DESIGN ADVISORY BOARD Tuesday October 25, 2016 at 3:00 PM Conference Room 12, City Hall, Burlington, VT Agenda

TO: Design Advisory Board
FROM: Ryan Morrison
DATE: October 25, 2016
RE: 17-0455CA, 57 South Williams Street

Request: A two-level addition of approximately 5,500 sf to the west side of the existing building, to provide a new worship sanctuary on the upper level, with supporting spaces on the lower level, with new off-street parking, landscaping, and erosion prevention.

PROPOSED SITE PLAN
CHABAD OF VERMONT
57 SOUTH WILLIAMS STREET
BURLINGTON, VT 05401

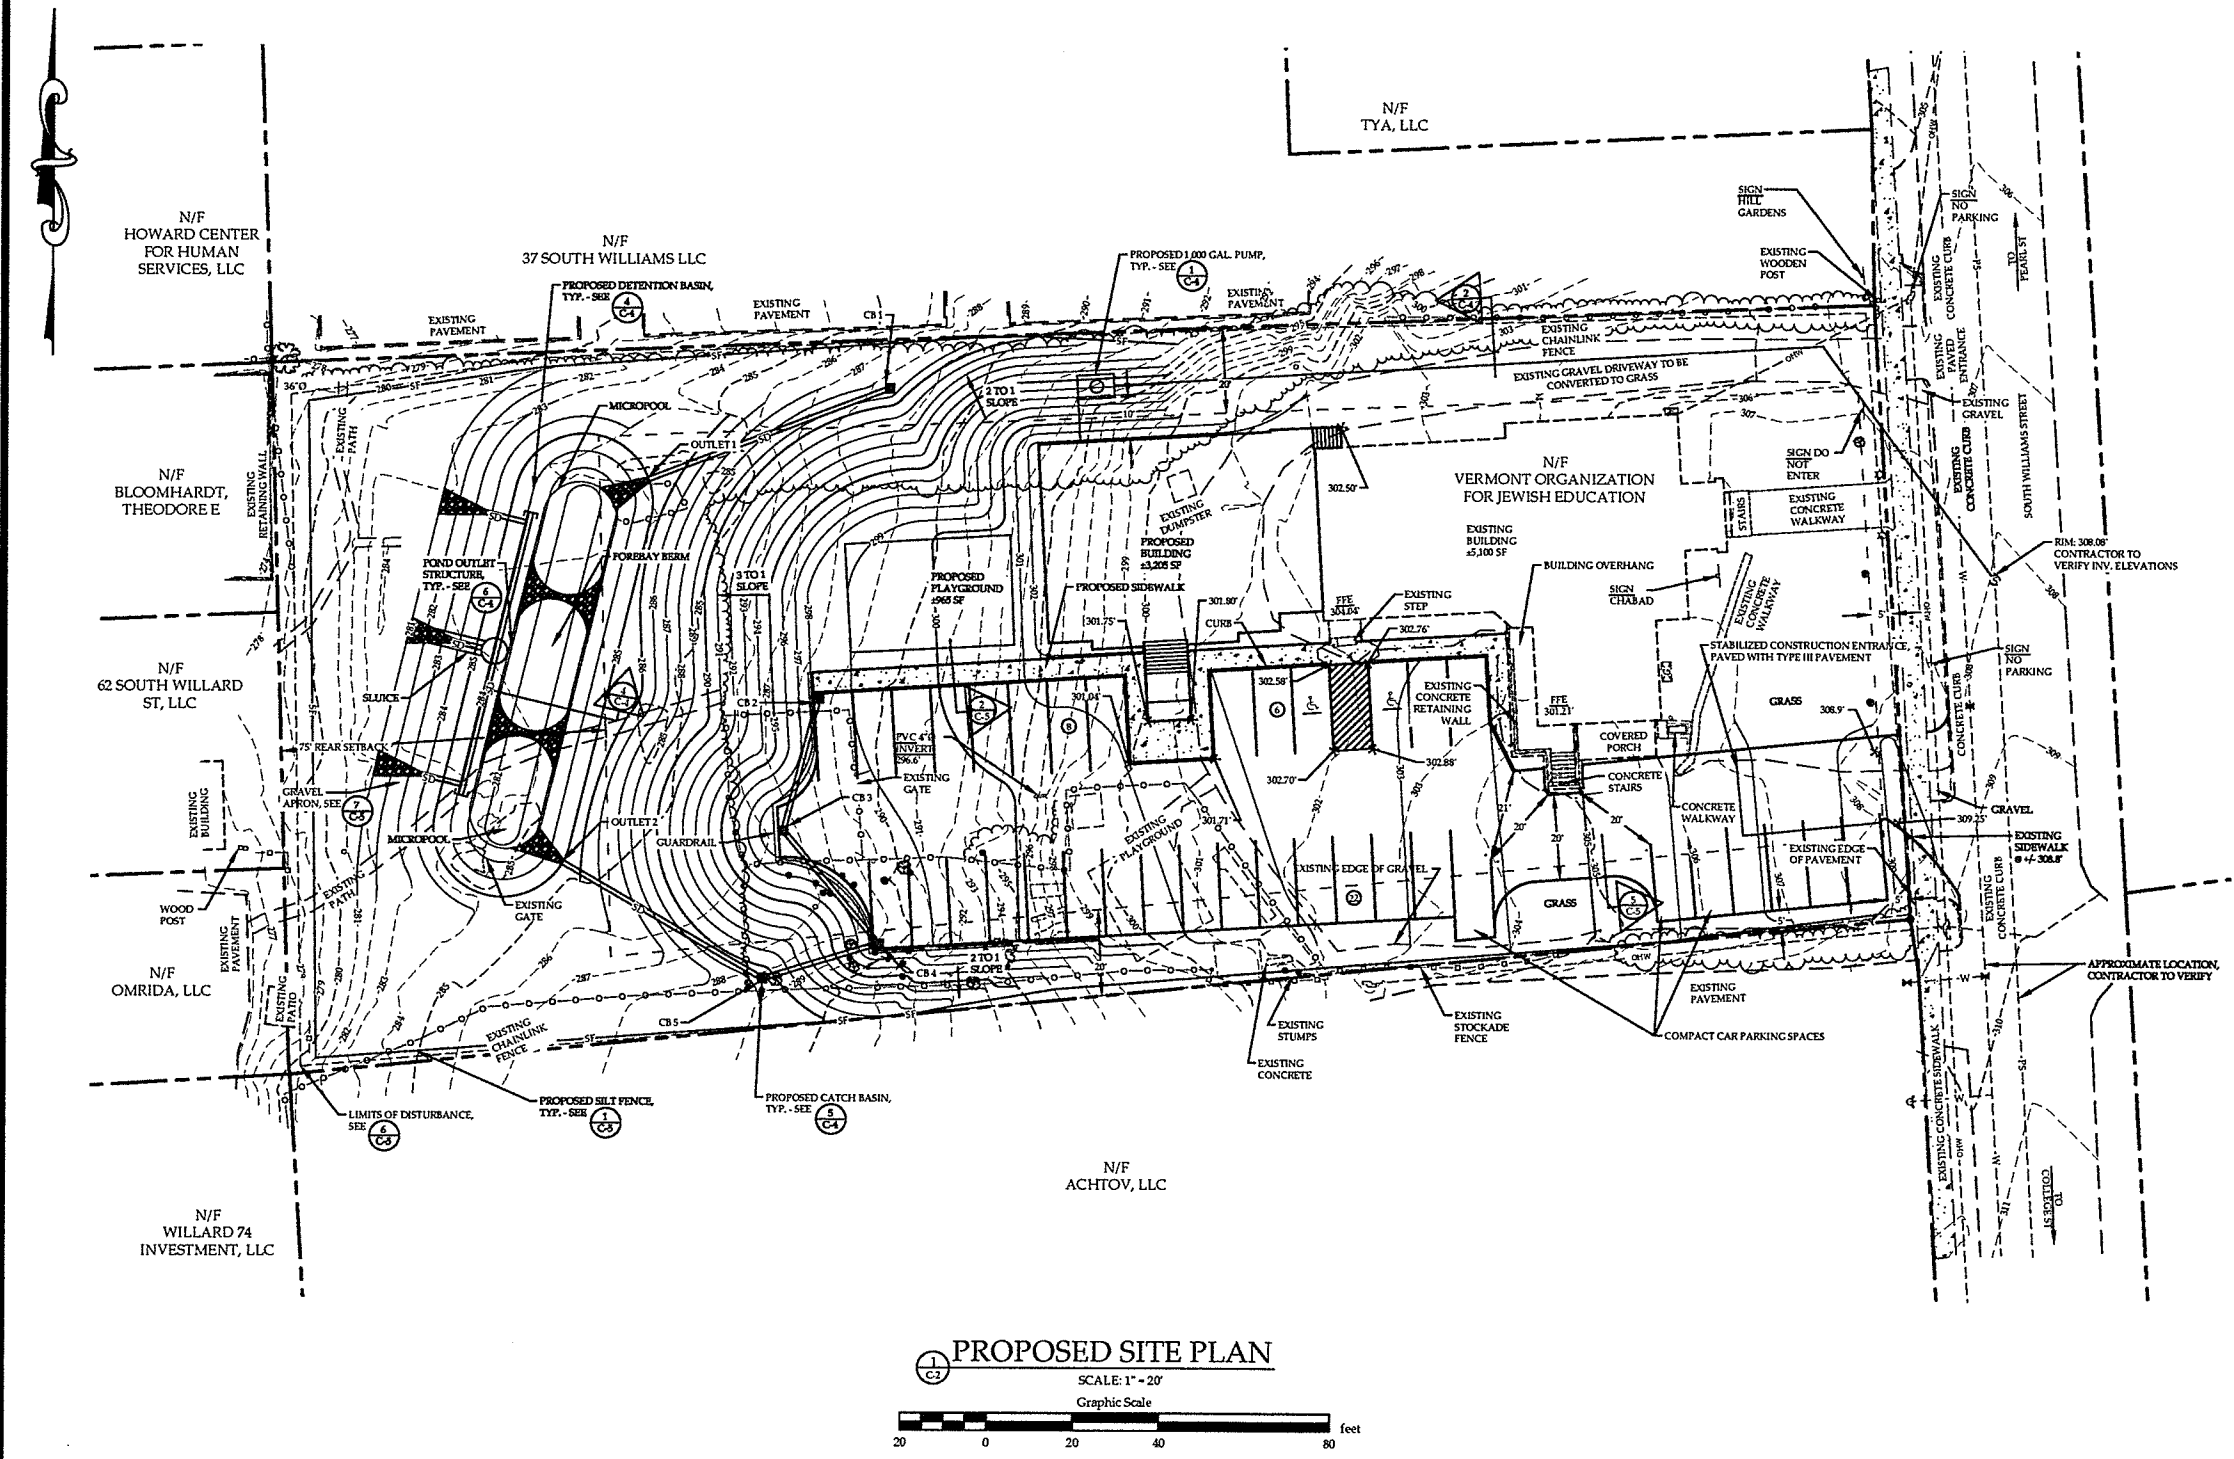
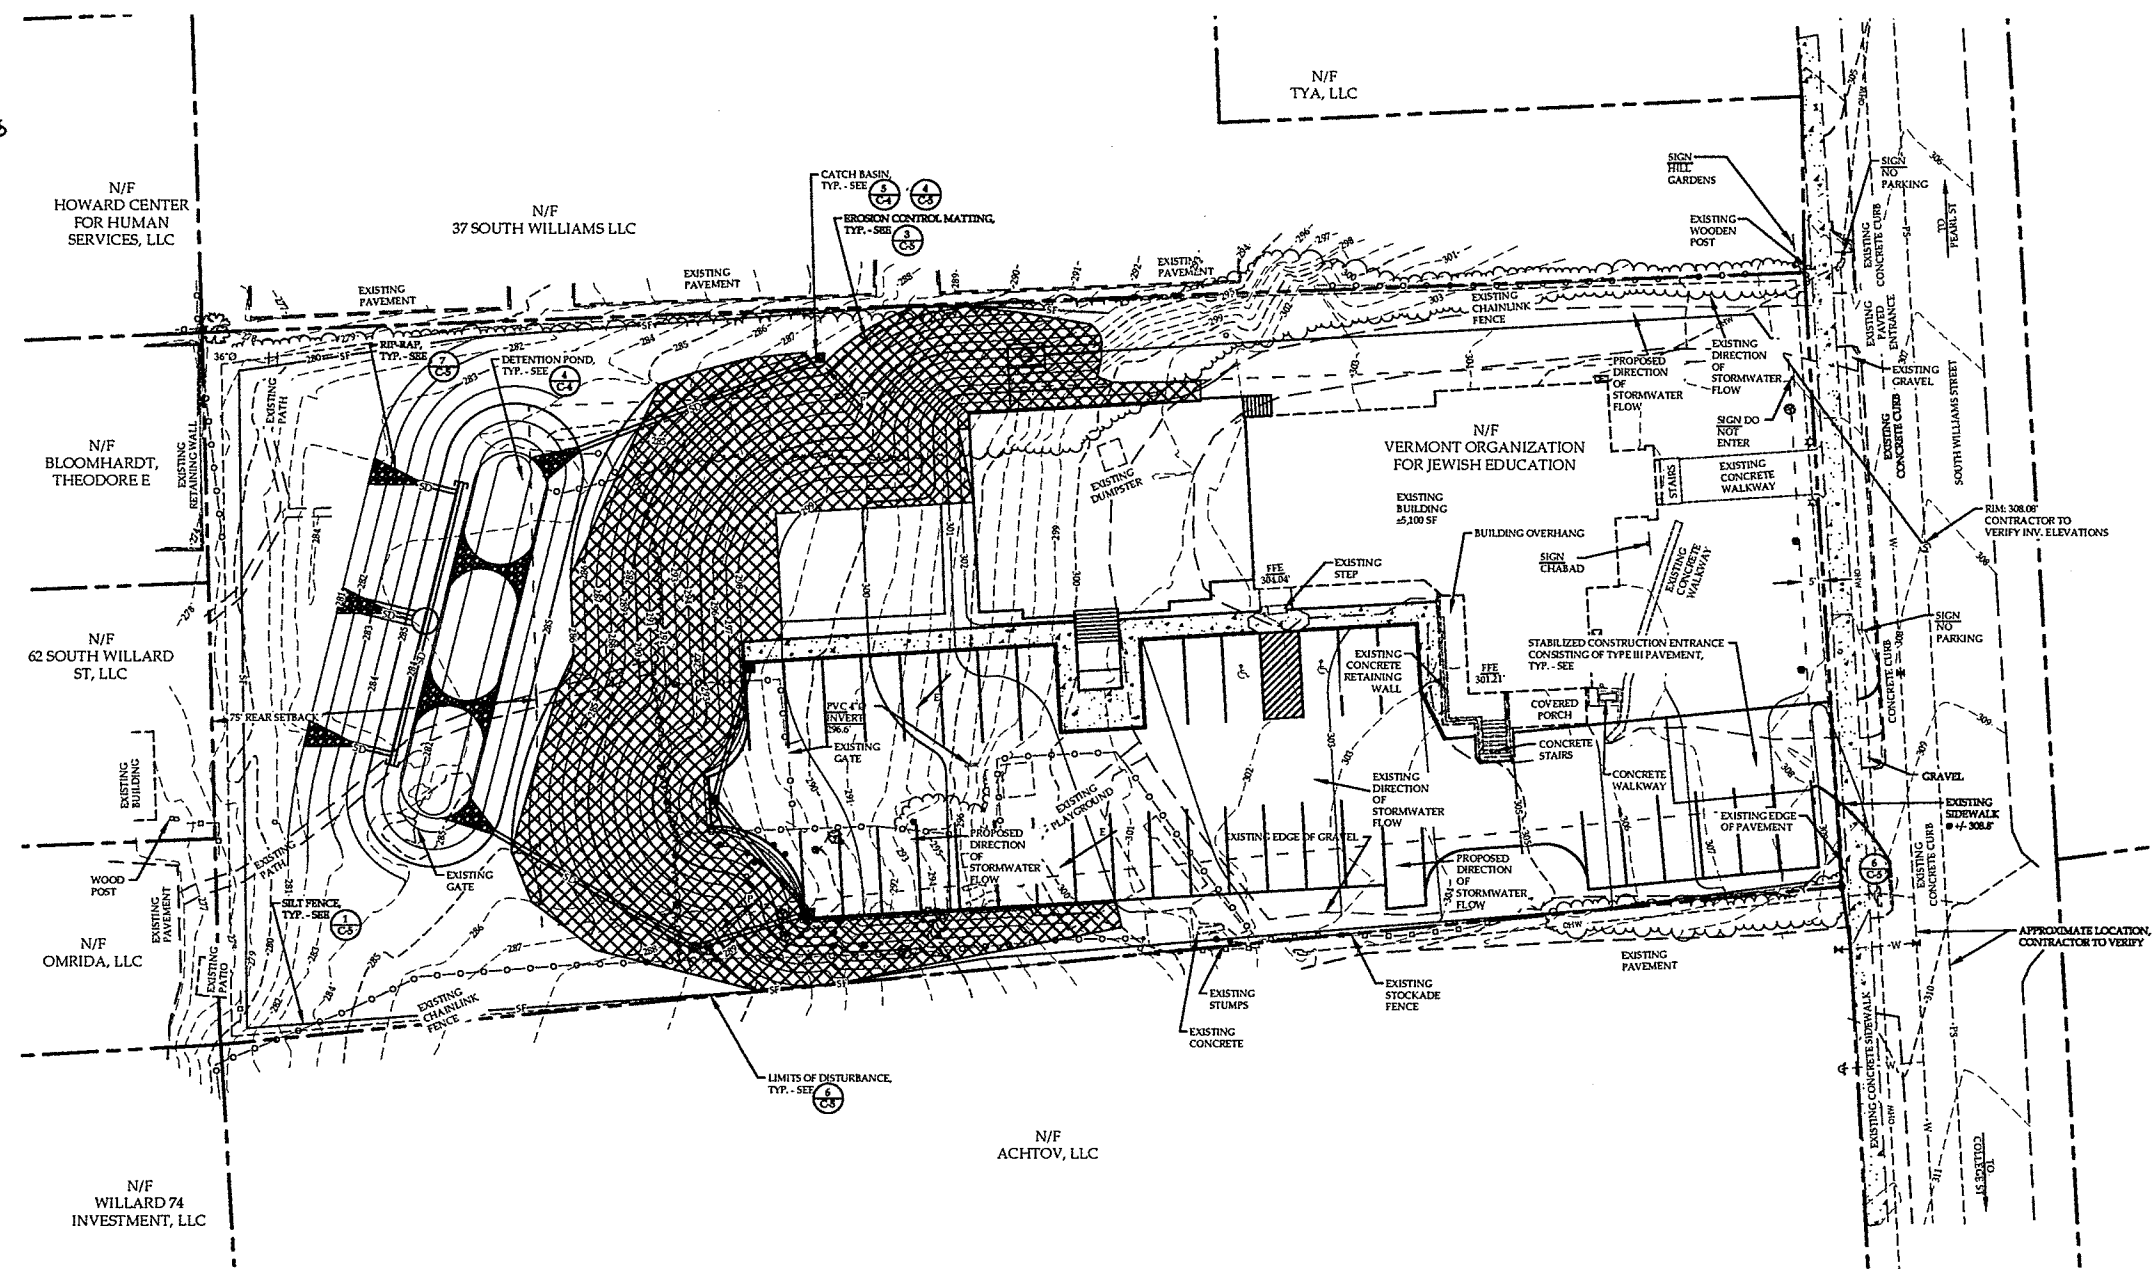
The proposed parking area depicts handicap parking spaces and all building entries appear to be accessible at grade. The proposal also includes direct access to the internal elevator. A curb cut providing ADA access between the parking area and the elevated walkway is not identified on the plan and needs to be.

Dimensionally, the parking spaces are slightly smaller than the standard. The parking spaces along the south property line are just 19' deep, whereas 20' is the standard. And similarly, the widths of all parking spaces are 8.5', whereas 9' is the standard. The depth of the 10 parking spaces in front of the existing building and proposed addition are at least 20' deep. The minimum 20' back-up space is provided between the two parking rows in the rear of the parking area. However, the back-up space provided for the existing parking spaces along the south property line ranges from approx. 12' to 17'. The proposal includes a vehicular turnaround at the rear of the parking area.

The proposal includes 25 new exposed surface parking spaces. Surface parking areas of 15 or more spaces require at least 1 shade tree for every 5 parking spaces. The landscape plan shows 3 shade trees along the south property line, 3 shade trees at the rear of the parking area, and 2 shade trees between the new parking spaces closest to the building addition and the proposed playground location. The shade trees must be 2.5" – 3" caliper at planting with an expected mature canopy of at least 25' diameter. At least 30% of the surface parking should be shaded. No shading analysis has been provided and must be.

The project plans do not include indoor or outdoor bike parking spaces. Additional details relative to type and number of bike parking spaces are needed.

All new utility lines must be buried. A heat-pump system is proposed that will have an outdoor mechanical unit. The location of this unit, as well as any other mechanical units, must be identified on the site plan. Mitigating and screening measures must be taken to minimize auditory and visual impacts from the public street and adjacent properties. A screened trash and recycling enclosure(s) will have to be included on the site plan as well. The dumpster must be set on a concrete pad.

1. The site plan shall be revised to include:
 - a. All required parking spaces;
 - b. All required bicycle parking spaces;
 - c. The location of the garbage/recycling area. Any dumpsters must be placed on a concrete pad;
 - d. A curb cut on the walkway along the south side of the addition to accommodate ADA accessibility; and
 - e. The location of the heat pump mechanical unit, and associated mitigation/screening.
2. The curb cut for the exit drive to the north of the building shall be removed.

3. A shading analysis for the surface parking shall be submitted.
4. Entry lighting levels shall be included with the photometric plan.
